REFERENCE	BT_2010_FR20_10_UK
DATE	2010 28th April
SUBJECT	Water circuit bleeding, internal gearbox checking, new allowed parts, pedalbox adjuster, radiator masking
PART	Engine water pump, gearbox, clutch master cylinder, diffuser stay, radiator net, pedalbox adjuster

Set of shims

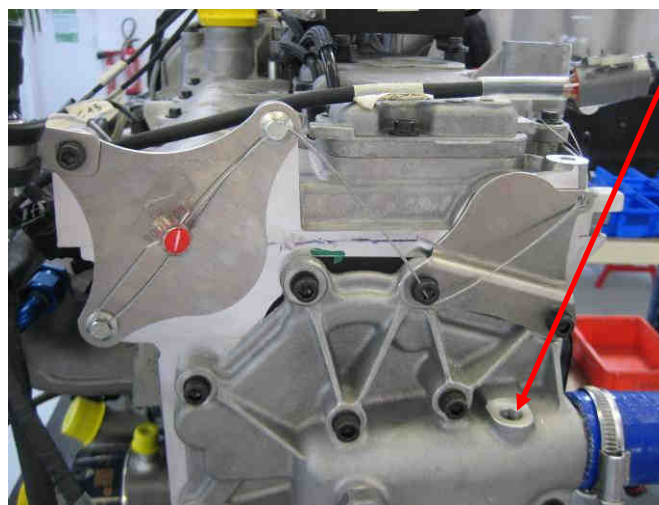
- Checking play between wheels/ dog ring hub setup

1. Selector forks and selector axle must be dismantled from the gearbox.
2. Complete secondary and primary shafts must be assembled with their locknuts in the gearbox.

3. Use the anti-splay plate (ref. FOUT1910007) to remove the primary shaft locknut.
4. Remove the anti-splay plate.
5. Remove the pinions (7th to 2nd gear) from the primary shaft.
6. Remove the primary shaft.
7. Use a set of shims to check the clearance between dog ring hubs and the wheels (for 2nd gear, 4th gear, 6th gear)

8. If there is not enough clearance, change the gear bearing inner race or the dog ring hub related to the wrong clearance.

Note: Changing the gear shim (ref. F19102121) will not have any effect on this clearance.

Minimum clearance: 0.1 mm
Maximal clearance: 0.25 mm

3. Clutch master cylinder

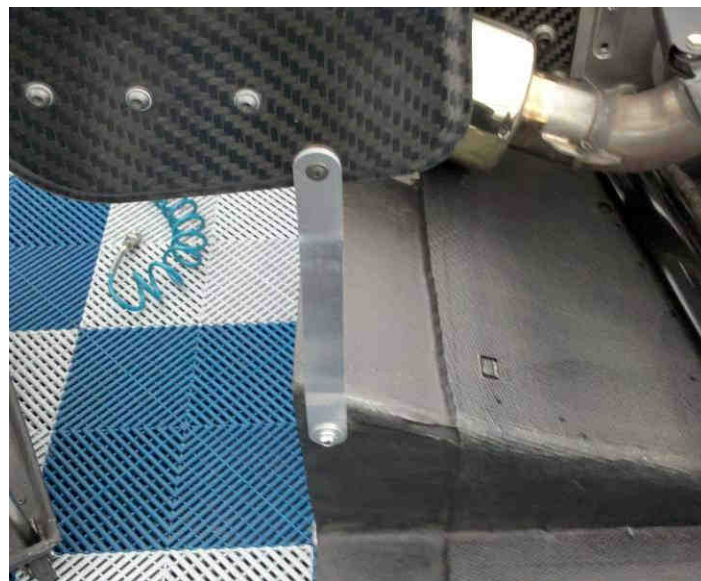
The 5/8" brake master cylinder (ref. 77 11 166 483) is now allowed to be used as clutch master cylinder. The use of this master cylinder should improve clutch behaviour.

You must be careful when setting-up the clutch pedal to correctly disengage the clutch mechanism.

You could damage the clutch mechanism if you push more than 5mm on the diaphragm.

Note: with this master cylinder, the neutral lever becomes too hard to pull. For safety reasons, a small modification must then be made on the neutral lever and will be explained on a next Technical Bulletin that will be released tomorrow (Thursday 29th May).

The maximal stroke of the clutch mechanism is 5mm which corresponds to a stroke of 15,1mm for the 5/8" master cylinder (compared to 19,5mm for the original one).
